Delegated Report		Analysis sheet		Expiry Date:		23/04/2025	
		N/A / attached		Consultation Expiry Date:		23/05/2025	
Officer				Application Number(s)			
Obote Hope				2025/0846/P			
Application Address				Drawing Numbers			
1 Spencer Rise London NW5 1AR							
PO 3/4	Area Team Signature	C&UD	Authorised Officer Signature				
Proposal(s)							
Erection of a mansard roof with a roof light, two dormers at the front behind the existing parapet, aligned to the windows below and one dormer at the rear, centred to the elevation.							
Recommendation(s):		Non-Determination: would have refused					
Application Type:		Householder Application					
Conditions or Reasons for Refusal:		Refer to Draft Decision Notice					
Informatives:							
Consultations							
Adjoining Occupiers:		No. notified	00	No. of responses	00	No. of objections	00
				No. electronic	00		
Summary of consultation responses:		Site notices were posted on 05/03/2025 and expired on 29/03/2025. Press notices were issued on 13/03/2025 and expired on 29/03/2025.

Site Description

View of unaltered roofline on northern side of Spencer Rise:

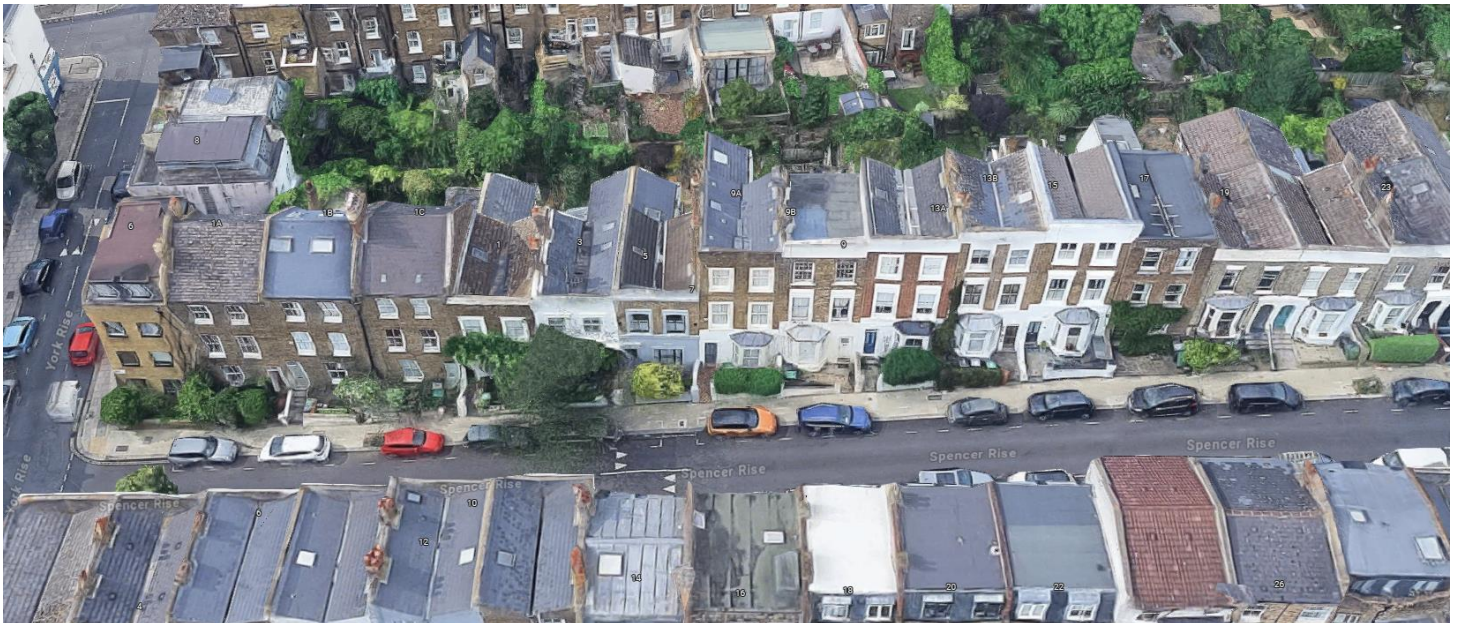
2.12 The guidance set out in the Conservation Area Statement is clear and relatively unequivocal about the likely unacceptability of roof extensions along the northern side of Spencer Rise, explicitly highlighting the negative impact and undue prominence of the current mansard roofs on Spender Rise. On basis of the above, the proposed mansard addition is considered unacceptable in principle for the following reasons-

- Would interrupt an unbroken row of valley roofs;
- Would break a terrace that has a roof line that is largely unimpaired by alterations or extensions – both the larger terrace of properties on the northern side of Spencer Rise and the small group of 3 buildings with which the application building forms a group; and
- The proposed extension would be contrary to specific guidance in the Conservation Area Statement highlighting that roof extensions would likely only be acceptable on the south side of Spencer Rise.
